May 24, 2010

RE: Lorain County
Wetlands & Tributaries to Black River
LORCO Phase I, Project # 083343
Notice of Violation

RE: Lorain County
Black River Watershed
Eaton Twp
LORCO Wastewater Collection System
and Pump Station (Contracts 1-5)

NOTICE OF VIOLATION

Fig 1 (LEFT). The end of the silt fence is turned downslope rather than upslope. This allows sediment-laden runoff to flow around the end rather than cause it to pond behind the fence.

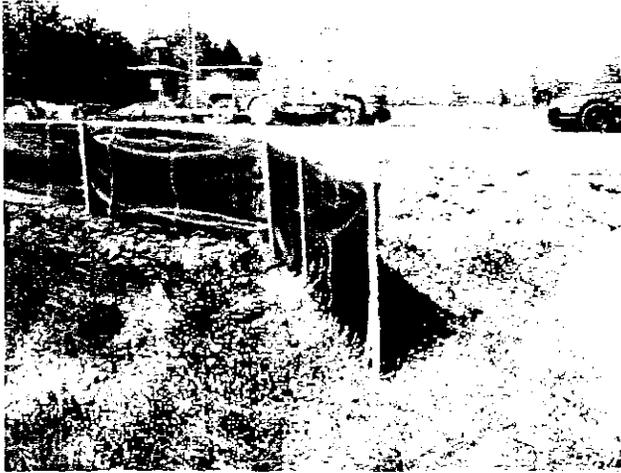
Fig 2 (RIGHT). There is no silt fence between the edge of disturbance for the Cowley Rd Pump Station and the drainage ditch.

Fig 3 (LEFT). No temporary stabilization of disturbed areas has been initiated along Cowley Rd.

Fig 4 (RIGHT). Storm drain inlet protection has not been constructed per approved specifications.

Fig 20 (LEFT). Cement trucks were washing out along the side of SR 83 in an area just upslope of a storm drain. No washout pit had been provided.

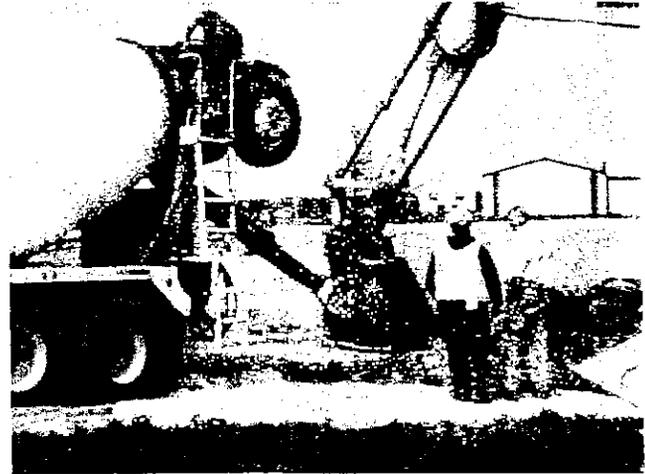
Fig 21 (RIGHT). A washout pit was hastily constructed at SR 83 and Cooley Rd. However, please note that the cement truck driver is washing out the drum and chute before the pit has been established even after he was just told that he was not permitted to wash out in an uncontained area.
